APPEAL SUMMARY

Appeal item 1  Code Section 2019 OSSC Section 1016.2-5  Requires Egress shall not pass through kitchens, storage rooms, closets or spaces used for similar purposes.  Code Modification or Allow egress through corridor with water holding tanks located on either side.  Proposed Design Corridor 154 will have a total of 3 water holding tanks placed along the walls on both sides of the corridor. The tanks will be 325 gallons and will hold reverse osmosis water only, the water will pumped to the tanks by pipes permanently affixed to the walls. These Water tanks are an integrant of the cultivation operation and are to be permanently fixed and not movable. This is a common operation setup for the industry.  Wing walls will be constructed at the ends of the tanks to create an alcove and clearly define the egress path through the corridor. A minimum of 44" clear egress path will be provided, a 51" circles.	Appeal Involves: Alte	ration of an existing structure	LUR or Permit Application No.: 21-062540-CO

### APPEAL DECISION

LEVEL 1 FLOOR PLAN - RESEARCH AND DEVELOPMENT

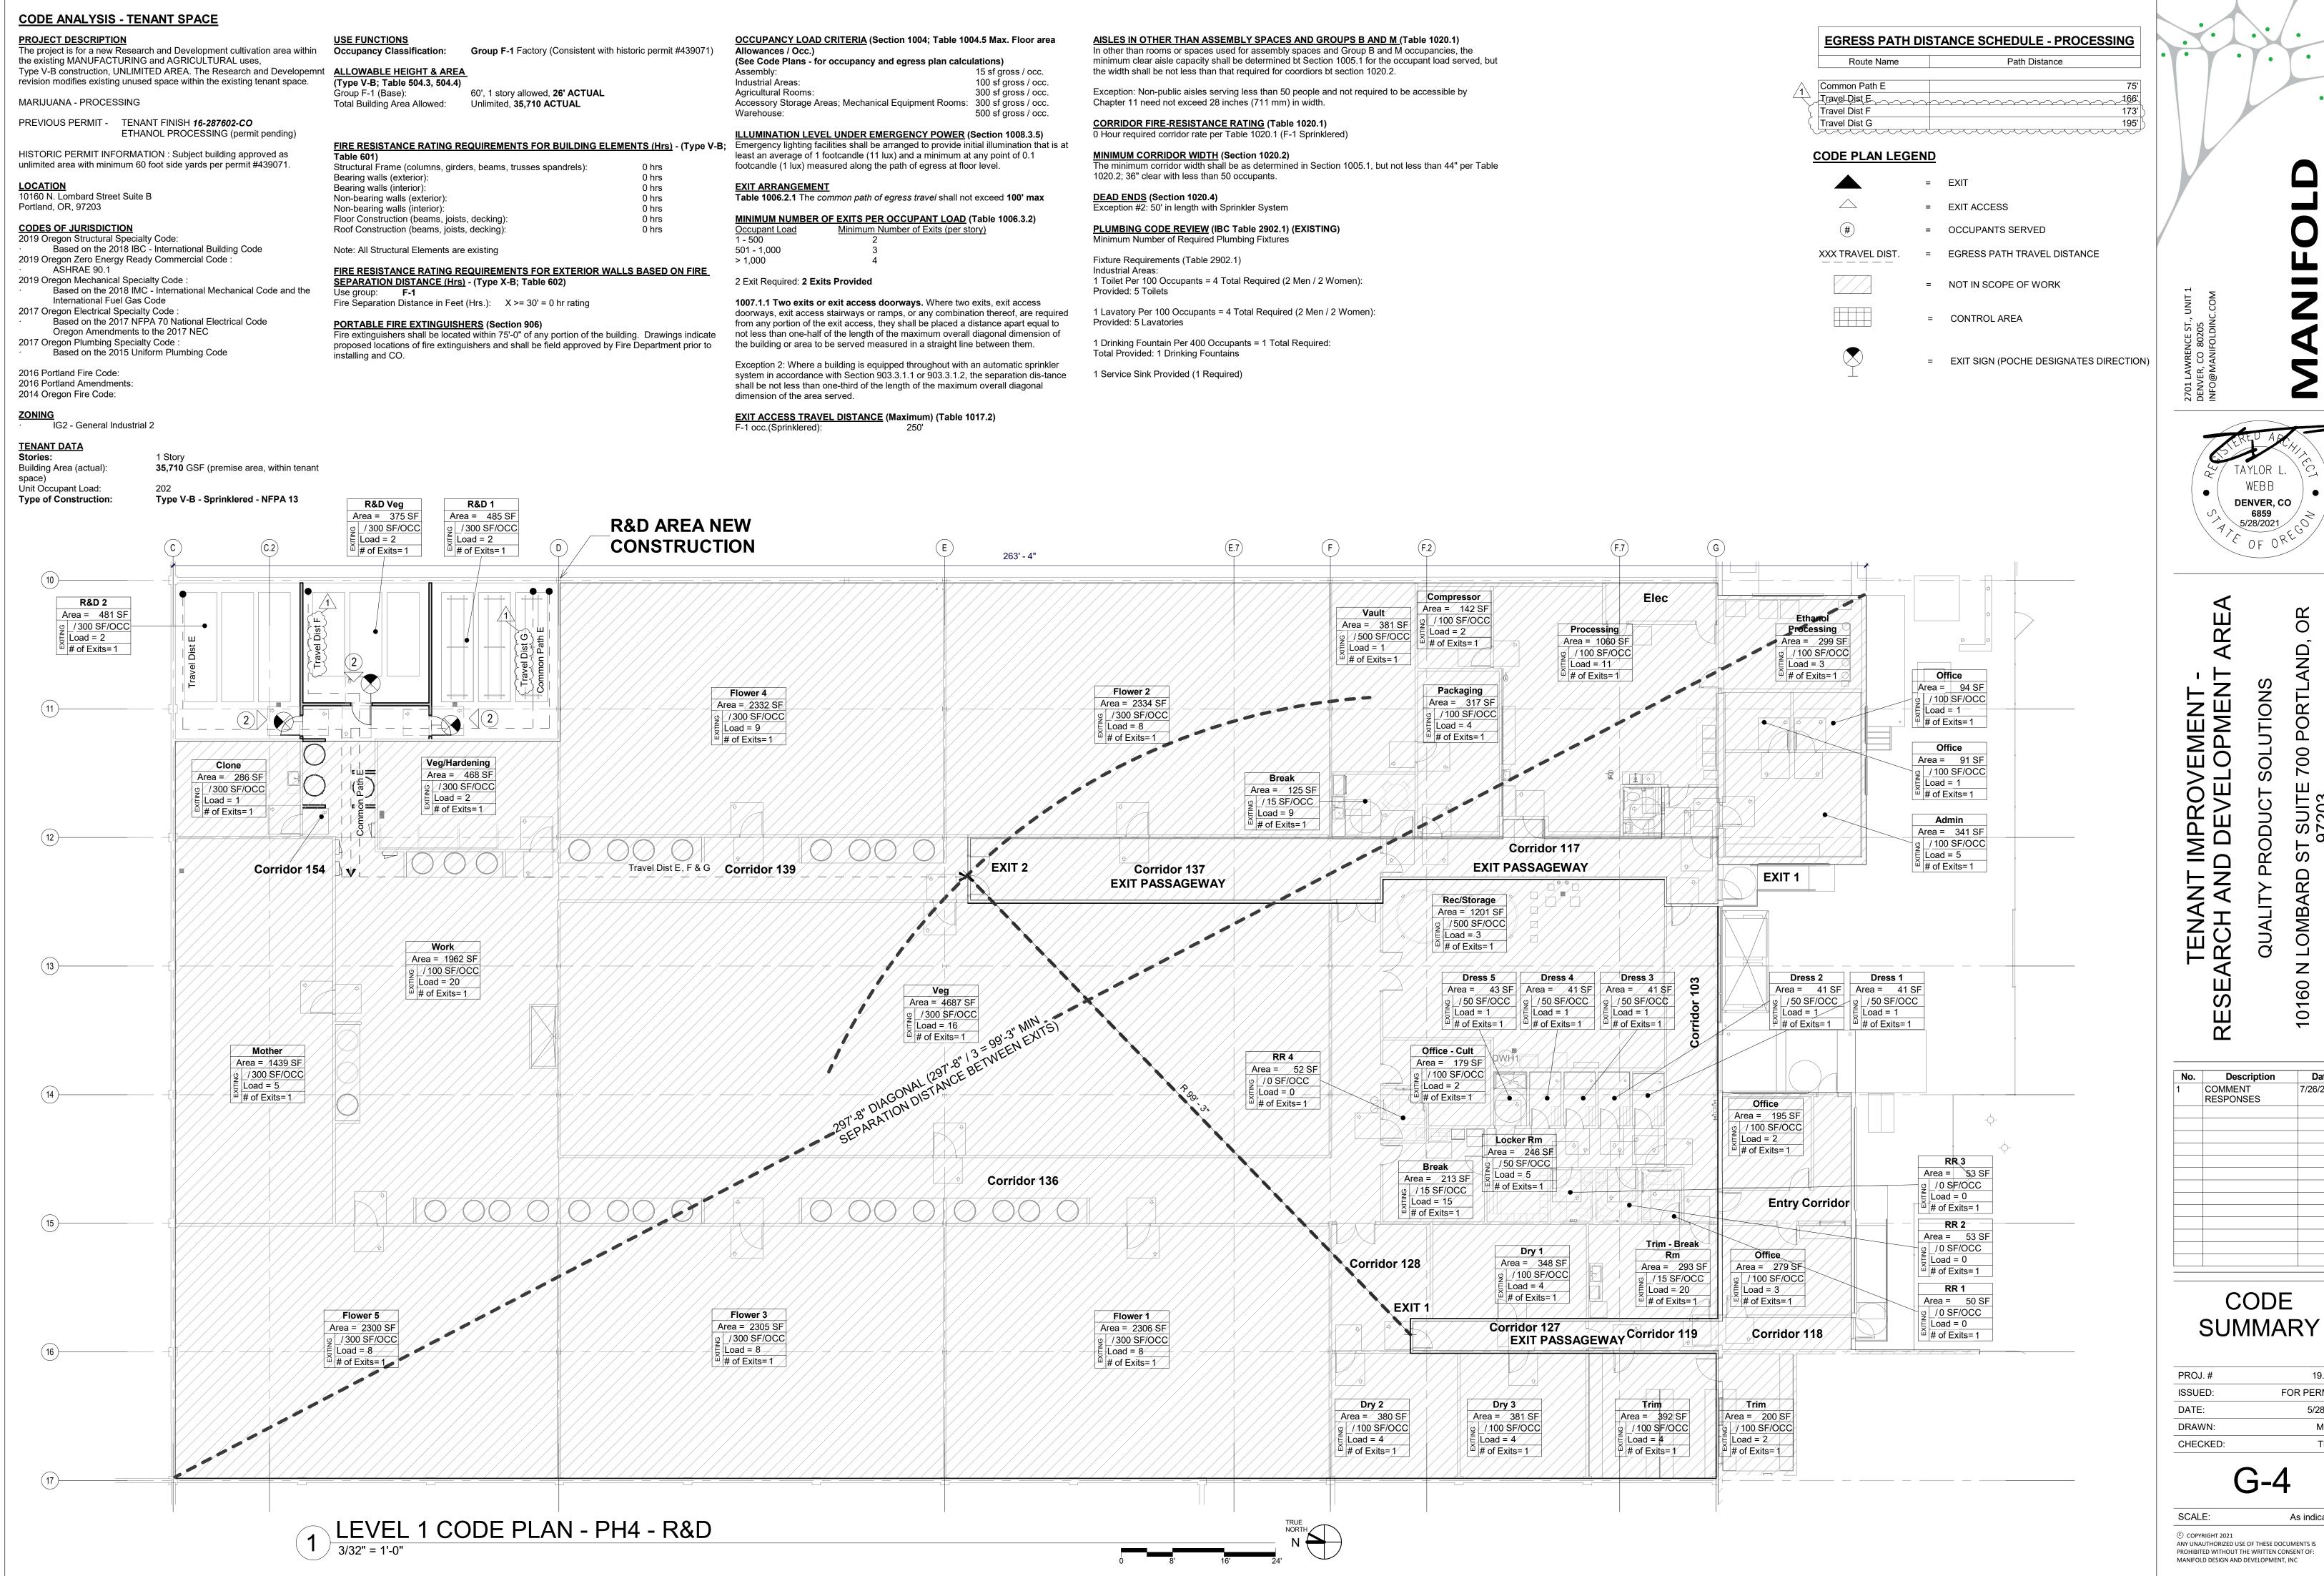
Proposed Design  Corridor 154 will have a total of 3 water holding tanks placed along the walls on both sides of to corridor. The tanks will be 325 gallons and will hold reverse osmosis water only, the water will pumped to the tanks by pipes permanently affixed to the walls. These Water tanks are an integrant of the cultivation operation and are to be permanently fixed and not movable. This is a common operation setup for the industry.  Wing walls will be constructed at the ends of the tanks to create an alcove and clearly define the egress path through the corridor. A minimum of 44" clear egress path will be provided, a 51" clear egress path will be provided, a 51" clear egress path will be provided.	Requires		
corridor. The tanks will be 325 gallons and will hold reverse osmosis water only, the water will pumped to the tanks by pipes permanently affixed to the walls. These Water tanks are an integrant of the cultivation operation and are to be permanently fixed and not movable. This is a common operation setup for the industry.  Wing walls will be constructed at the ends of the tanks to create an alcove and clearly define the egress path through the corridor. A minimum of 44" clear egress path will be provided, a 51" clear egress path will be provided.		Allow egress through corridor with water holding tanks located on either side.

egress path through the corridor. A minimum of 44" clear egress path will be provided, a 51" cl	Proposed Design		
egress patris indicated on the drawings.		Wing walls will be constructed at the ends of the tanks to create an alcove and clearly define the egress path through the corridor. A minimum of 44" clear egress path will be provided, a 51" clear egress path is indicated on the drawings.

Water storage tanks within corridor: Granted provided curbs are installed of sufficient height to contain the contents equivalent of a full single tank in the event of a leak or rupture.

Reason for alternative The proposed design provides a clear egress path per the intent of the code and per previously
